Access Compliance Report

Public Rights-of-Way

(Curb Ramps)

Intersection ID: 14833	Main Street: ALBEMARLE_RD	Cross Street: MARTIN_LAKE_RD	Location:	S
ADA ID: F1DF7ED96411	Ramp Type: Perp	Initial Pass/Fail: Fail	Overall Compliance: No	Severity Score: 12.5
Codes/Mitigation Info/Possible Solution		Field Measurements/Component Compliance

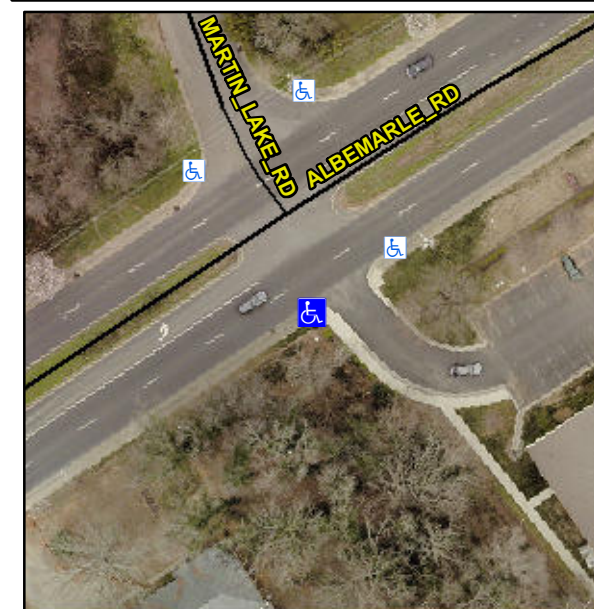
R304.2.2

Compliance	Description	Data	Compliance	Description	Data
N/A	Ramp Length (in)	63.0	No	Ramp Slope (%)	8.7
Yes	Ramp Width (in)	48.0	Yes	Ramp XSlope (%)	1.8
N/A	Flare Type LT	N/A	N/A	Flare Type RT	N/A
N/A	Flare Slope LT (%)	N/A	N/A	Flare Slope RT (%)	N/A
N/A	Flare Traversable LT?	N/A	N/A	Flare Traversable RT?	N/A
N/A	Landing Length (in)	N/A	N/A	DWS Provided?	N/A
N/A	Landing Width (in)	N/A	N/A	DWS Contrast?	N/A
N/A	Landing Slope (%)	N/A	N/A	DWS Length (in)	N/A
N/A	Landing X Slope (%)	N/A	N/A	DWS Full Width?	N/A
N/A	Landing Curb? (Y/N)	N/A	N/A	DWS Offset (in)	N/A
N/A	Shared Landing?	N/A			
N/A	Gutter Ponding?	N/A	N/A	Gutter Slope (%)	N/A
N/A	Gutter Lip Ht (in)	N/A	N/A	Gutter X Slope (%)	N/A
N/A	Painted X Walk1?	No	N/A	Painted X Walk2?	N/A
	X Walk 1 Direction	To N		X Walk 2 Direction	N/A
N/A	X Walk 1 Width (in)	N/A	N/A	X Walk 2 Width (in)	N/A
	X Walk 1 Slope (%)	3.2		X Walk 2 Slope (%)	N/A
	X Walk 1 X Slope (%)	1.0		X Walk 2 X Slope (%)	N/A

Remove & Replace Entire Ramp.
